From: Hackett, John [John.Hackett@aptim.com]
Sent: Monday, October 19, 2020 4:45 PM
To: Mccray, Sean-Ryan CTR (USA) [sean-ryan.mccray.ctr@navy.mil]
CC: Stoick, Paul T CIV USN NAVFAC SW SAN CA (USA) [paul.stoick@navy.mil]; Johnson, Nels [Nels.Johnson@aptim.com]; Bercik, Lisa M. [lisa.bercik@aptim.com]
Subject: [Non-DoD Source] HPNS Parcel D-2/UCs RTC and RLSO Files 1 of 2
Attachments: WP Fig6_UC3_Trenches (Rev1).pdf; DF RAWP Oct 2020 RLSO .docx; WP Fig1_Site_Location (Rev1).pdf; WP Fig2_Site_Layout (Rev1).pdf; WP Fig3_D2_Trenches (Rev1).pdf; WP Fig5_UC2_Trenches (Rev1).pdf; Response to Comments - D RAWP 2020_07_13 - PS APTIM.docx

**DRAFT FINAL
REMOVAL SITE EVALUATION WORK PLAN**

Radiological Confirmation Sampling and Survey
Parcels D-2, UC-1, UC-2, and UC-3

FORMER HUNTERS POINT NAVAL SHIPYARD
SAN FRANCISCO, CALIFORNIA

FIGURE 3
SOIL AND BUILDING SITES
PARCEL D-2 (PHASE 1, PHASE 2,
AND BUILDING SURVEY AREAS)
RADIOLOGICAL CONFIRMATION SAMPLING AND SURVEY
AT PARCELS D-2, UC-1, UC-2, AND UC-3
HUNTERS POINT NAVAL SHIPYARD, SAN FRANCISCO, CA

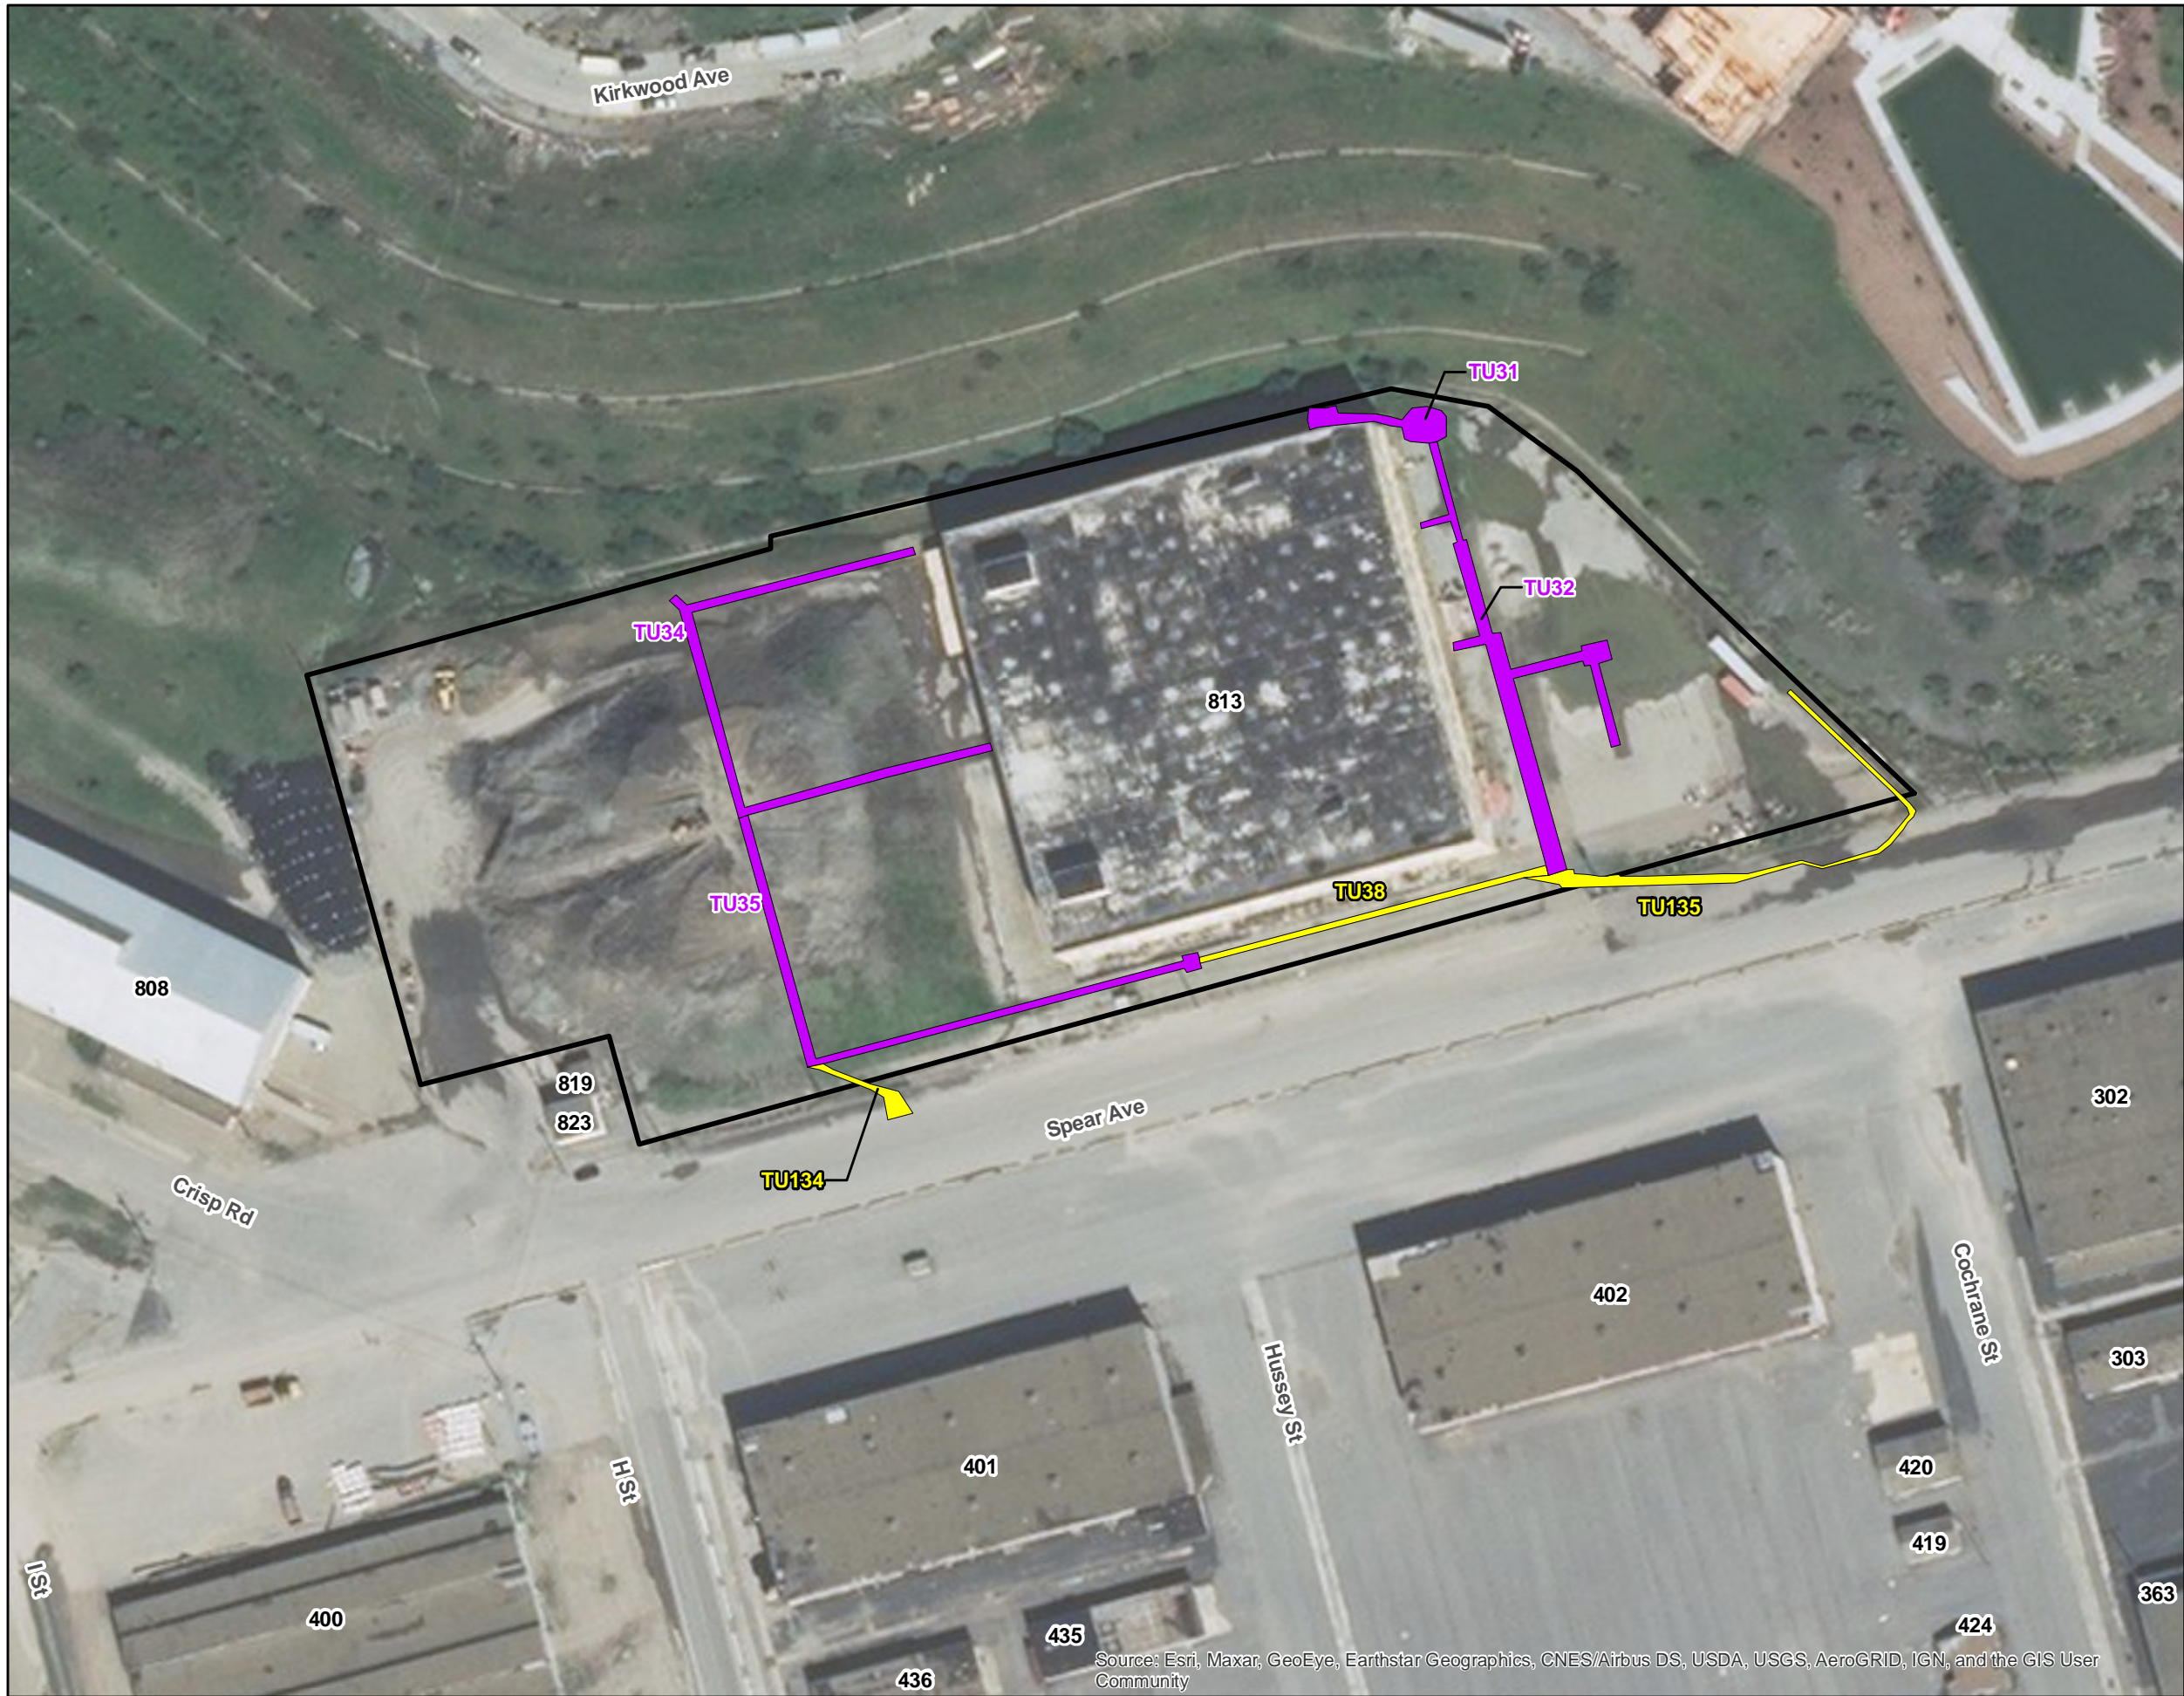
<p>7. Section 3.1.1.4 "Step Four- Define the Study Boundaries", Page 3-1, Paragraph 1. Sentence 1: "Tables 3 and 4 present Phase 1 and Phase 2 trench locations (Figures 3 through 6)." Trench Unit 184 and 184A are listed in Table 3 and Table 4 respectively. However, in Figure 6 the area in front of the Building 816 is labeled as TU184A and TU184B. Furthermore, the same area in front of the Building 816 designated as 2 separate TU 184's in current Work Plan was labeled as just one Trench Unit 184 in Navy's <i>Draft Radiological Data Evaluation Findings Report for Parcel D-2, UC-1, UC-2, UC-3 Soil</i>, Former Hunters Point Naval Shipyard San Francisco, California October 2017. Please explain the decision of splitting the trench unit 184 into 2 separate units in the current Work Plan, and the discrepancy in designation among the Table 3, Table 4 and Figure 6.</p>	<p>TU-184 is physically separated into two sections. Section 6.3 of the <i>Final Radiological Removal Action Plan for UC3, Hunters Point Naval Shipyard, San Francisco, California</i> (2012), "This trench unit is physically separated. The north section of TU184 connects to TU17 (Area 16 Central) on the west, and TU187 (Area 16 Southern) on the south. The southern section of TU184 connects to TU187 (Area 16 Southern) on the west and terminates at Manhole MH5. The south section of TU184 was terminated with the removal of a concrete pipe grouted into a trench. For clarity, as well as ease of discussion, the trench unit 184 and 184A which are both part of the same trench unit will be referred to as TU-184. The response to CDPH Comment 5. For consistency, the same nomenclature and TU-184A will be used. Table 4 has been updated to include TU-184A.</p>
